Responses to Questions Raised by FERC Staff on Oroville Facilities Relicensing Site Tour

1. *Provide a description of the specific proposed enhancements at McCabe Creek*

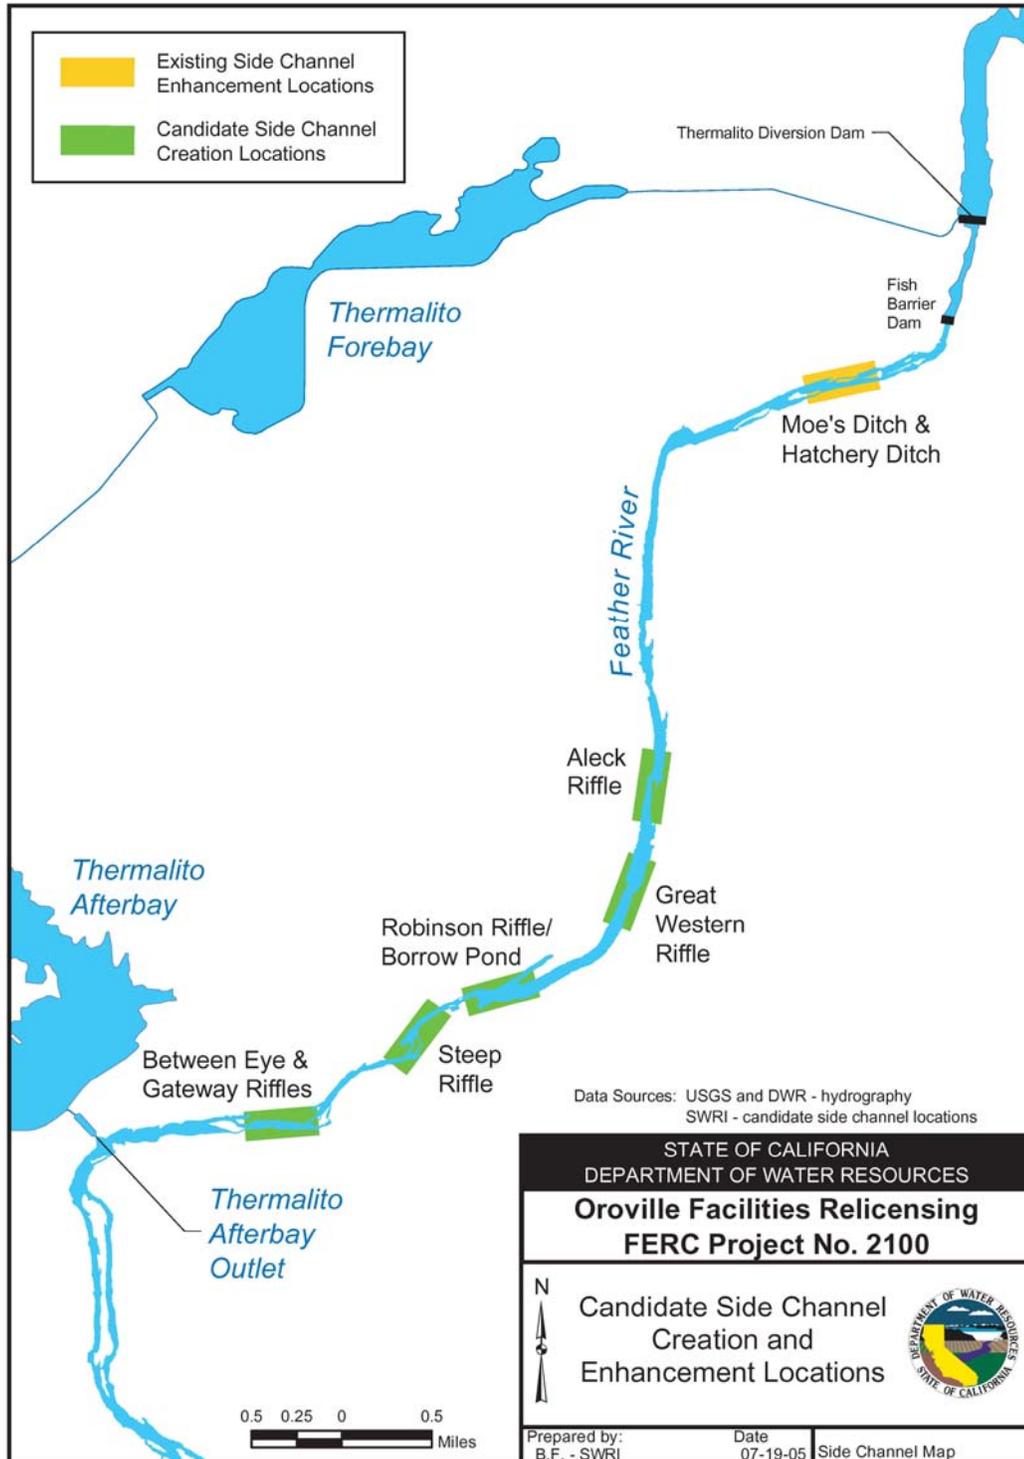
6. *For PME A-1 (for Alternative 2), please provide a description and location for each enhancement (including location on a map) proposed for the Lower Feather River, and break down the proposed \$8 million to correlate to the specific enhancement measures. Additionally please confirm if the \$8 million includes Alternative 2 measures at Shanghai Bench and Sunset Pumps. If not, please provide a description and costs for the Alternative 2 enhancements. Please confirm that PM&E A-1 for Alternative 2 also includes enhancements of Hatchery Ditch and Moe's Ditch, as in PM&E A-1 for the Proposed Action.*

PME A-1 (for Alternative 2) is actually the map code for *Side-Channel Habitat Improvement Program – along Low-Flow Channel* and it includes the Proposed Action (enhancements to Hatchery Ditch and Moe's Ditch) and the creation of additional side channels. The costs for these measures are included in Table 6.2-3 under the item for *Natural Salmonid Spawning and Rearing Habitat* and not part of the \$8 million for the item identified as *Lower Feather River Fishery*. The \$8 million included in Table 6.2-3 under item *Lower Feather River Fishery* includes Alternative 2 measures for Shanghai Bench and Sunset Pumps.

Description for A-1 (Alternative 2), Side-Channel Habitat Improvement Program – Along Low-Flow Channel:

lack of channel sinuosity. Moe's Ditch is quite broad and has little flow. A beaver dam backs up the flow in much of the channel, creating a large area of pool habitat. The most immediate need for restoring habitat in Moe's Ditch is to remove the gravels that restrict flow from the river channel. If the channel was opened the flow entering the ditch might wash out the beaver dam. Otherwise the dam would have to be removed mechanically. The improvements would likely include changes to the channel morphology, adding gravel to improve substrate, improved riparian and instream cover and improved water supply. The approximate location of this ditch is shown on Volume VII, Figure 3.2-1 in the License Application, and on the enclosed map. The estimated cost of improvements to Moe's Ditch is approximately \$400,000.
